Omaha Public Power District
444 South 16th Street Mall
Omaha NE 68102-2247

May 20, 1996
LIC-96-0072

SUBJECT: Additional Information to Assist Closure of NRR Staff Review of Fort Calhoun Nuclear Plant Individual Plant Examination (IPE) Submittal (TAC No. M74412)

Clarification of HRA Issues
Fort Calhoun Station Individual Plant Examination

Figure B-1. FESD for long-term recovery action.

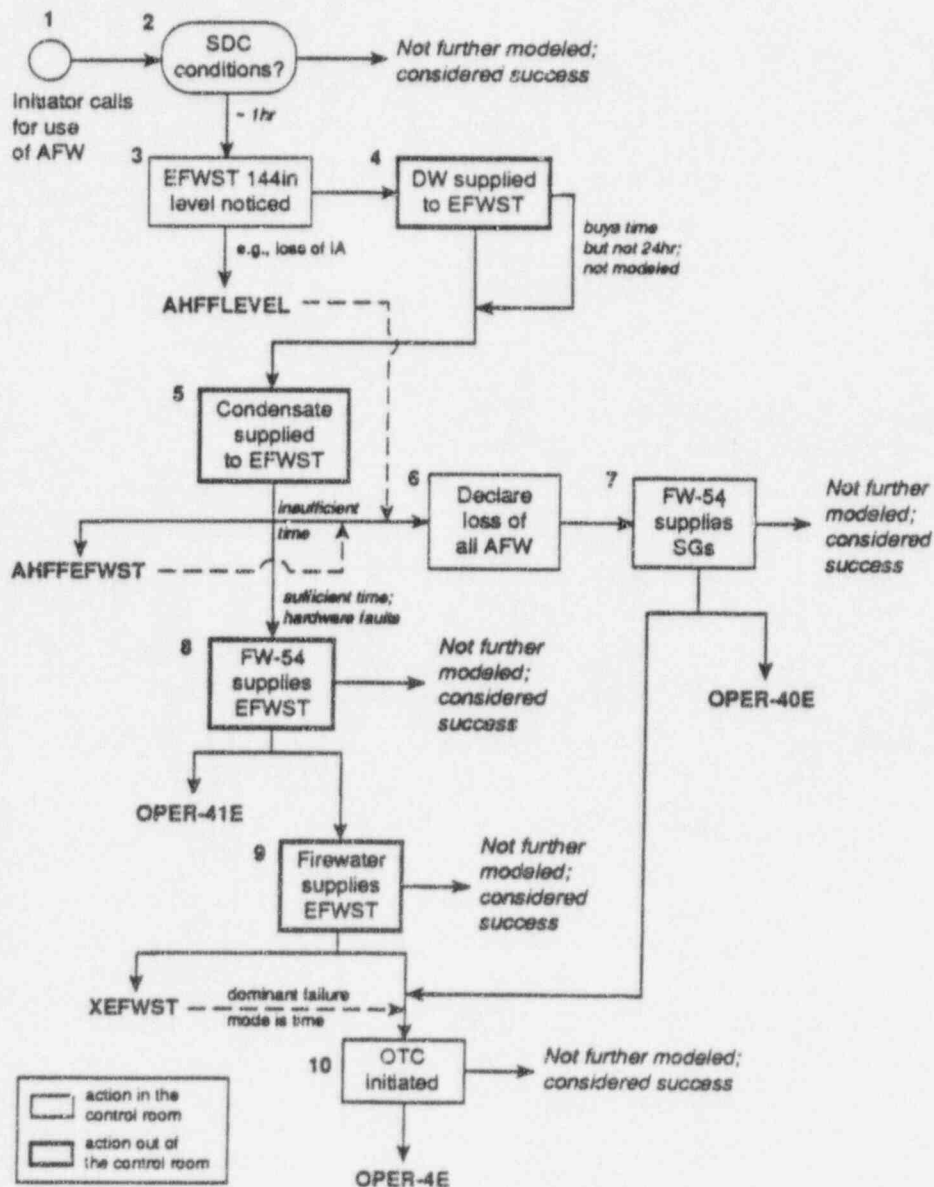
Lack of documentation/rules for the HRA process may limit usefulness of the IPE for future plant configuration or licensing changes, especially if the previous expertise is unavailable.

The additional guidance which follows has been provided by OPPD's HRA consultant. This guidance is currently being used for HRA work, and will be incorporated into the PRA procedures which are under development.

HFEs are identified in the system/event modeling effort or as part of the recovery analysis. Typically they are identified as a natural part of the fault tree/event tree modeling for sequences. Sometimes a special depiction of an event and its contingencies is made in a functional event sequence diagram (FESD). Figure B-1 in the HRA notebook is an example. This figure is included on Page 6.
